LAX/Community Noise Roundtable

Work Program A1 – Initial Review of the
Final Environmental Assessment
for the FAA SoCal Metroplex Project

September 14, 2016

Proposed LAX West Flow STARs

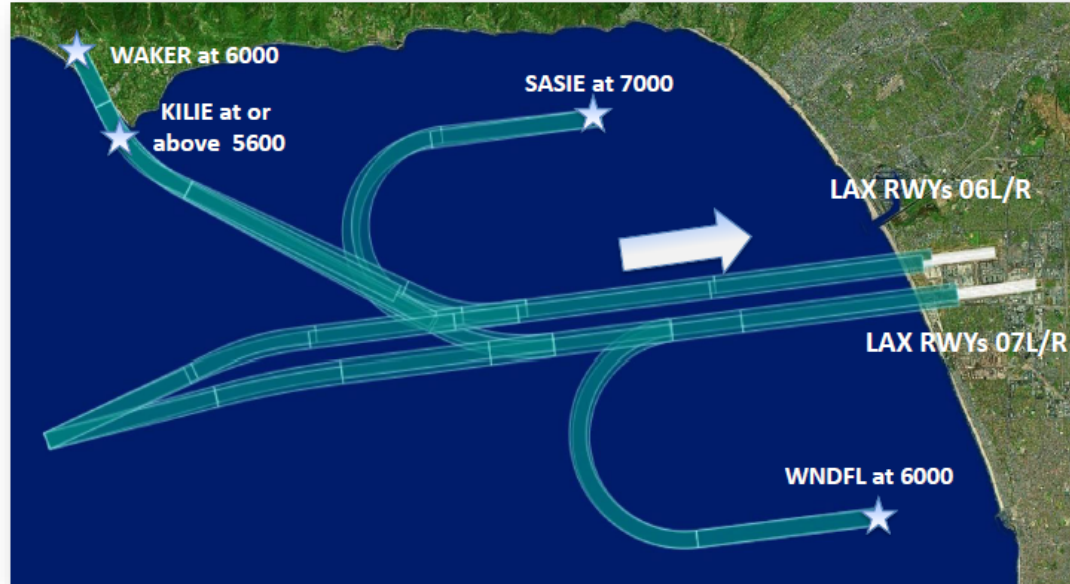
- The Metroplex Design Team developed STARs for LAX arrivals landing on west bound runways
- The current procedure routes aircraft over the SMO ground based navigational aid
- After the Metroplex Team considered community input, CLIFY waypoint (vertical restriction of 7000 through 8000) was repositioned to a point within 120 feet of the SMO ground based navigational aid to remain within historical tracks descending to 7000 feet
- The DAHJR waypoint has a vertical restriction of 6000 feet which will cause arrivals to remain at higher altitudes than current state until east of Culver City
- The Metroplex Design Team reviewed vertical restrictions on the STARs and determined no other changes to the proposed procedure were feasible

Proposed LAX ZUMMA STAR

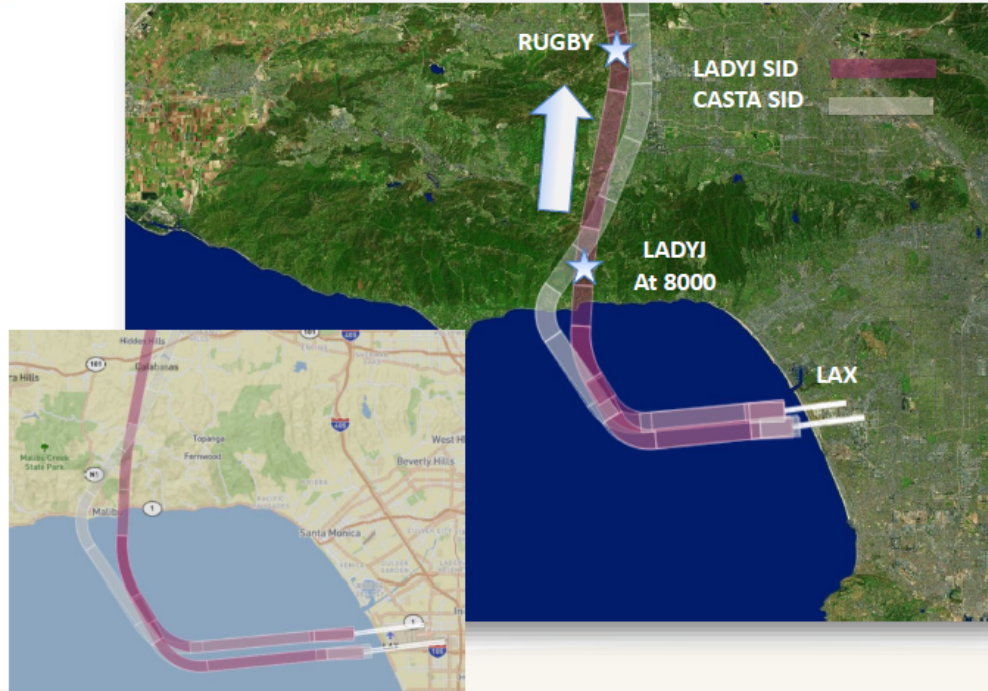
- The Metroplex Team designed the LAX ZUMMA STAR for aircraft landing on eastbound LAX runways, arriving from over the ocean
- Industry representatives requested a runway transition in order to simplify flightdeck automation.
- The Metroplex team developed runway transitions beginning at WAKER and also added the new waypoint KILIE in order to route LAX arrivals further offshore before beginning turn towards the airport.

Proposed LAX LADYJ SID

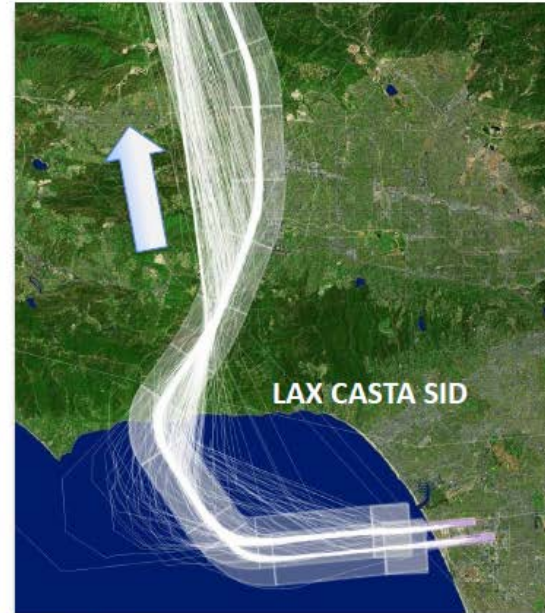
- The Metroplex Team developed the LAX LADYJ SID (original name MLIBU SID) to replace the current LAX CASTA SID
- The lateral track of the LADYJ SID was developed to mitigate aircraft flightdeck collision avoidance warnings (TCAS) identified through safety data
- The Metroplex Team considered community input and re-examined the crossing altitude at the LADYJ waypoint of 8,000 feet. The Team determined that raising the altitude restriction to 9,000 feet was not feasible due to the need to separate LADYJ departures from LAX arrivals on the LAX IRNMN, HULLL and CRSR STARs. The Metroplex Team added a new waypoint RUGBY, moving the procedure to more closely follow historical tracks.

Proposed Santa Monica (SMO) CTRUS SID

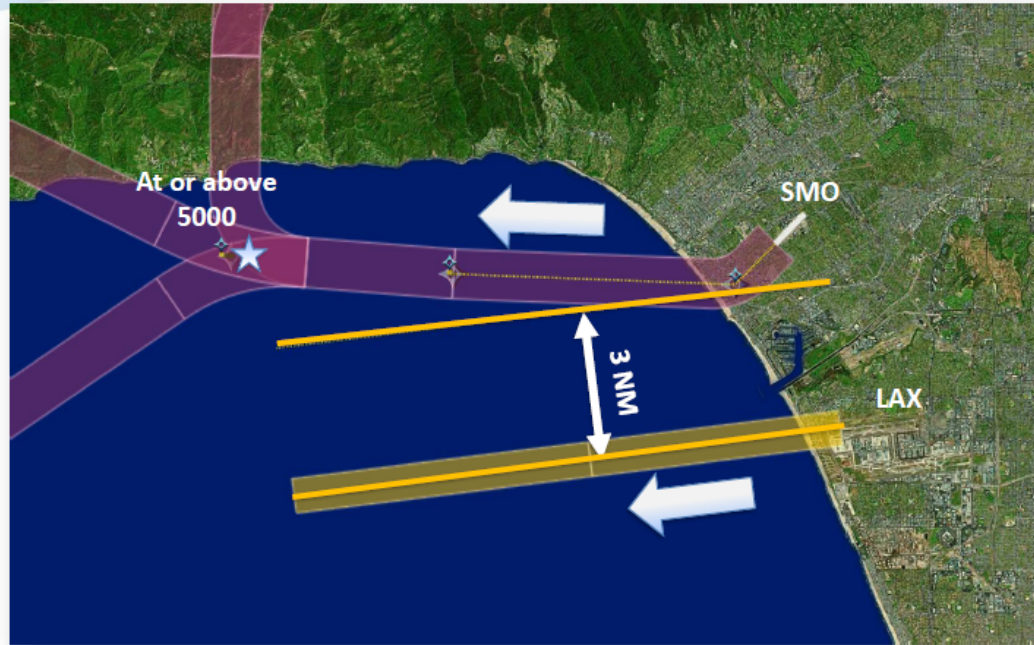
FAA Reviewed Community Input, No Change Possible

Comments to turn SMO departures sooner or maintain runway heading longer did not meet terrain and departure separation requirements.

- The SMO CTRUS SID is for SMO departures from Runway 21
- One of the purposes of the Metroplex Project is to increase efficiency of the NAS by de-conflicting (3 NM required) the departures to the west from the SMO and LAX airports and reducing delays greater than 15 minutes.
- Aircraft depart on runway heading, then make a right turn prior to reaching the shoreline in order to provide required separation between departures from SMO and Los Angeles International Airport (LAX) Runway 24R
- The Metroplex Team considered community input, re-examining the CTRUS SID and determined that due to terrain and separation requirements no changes to the proposed procedure were feasible
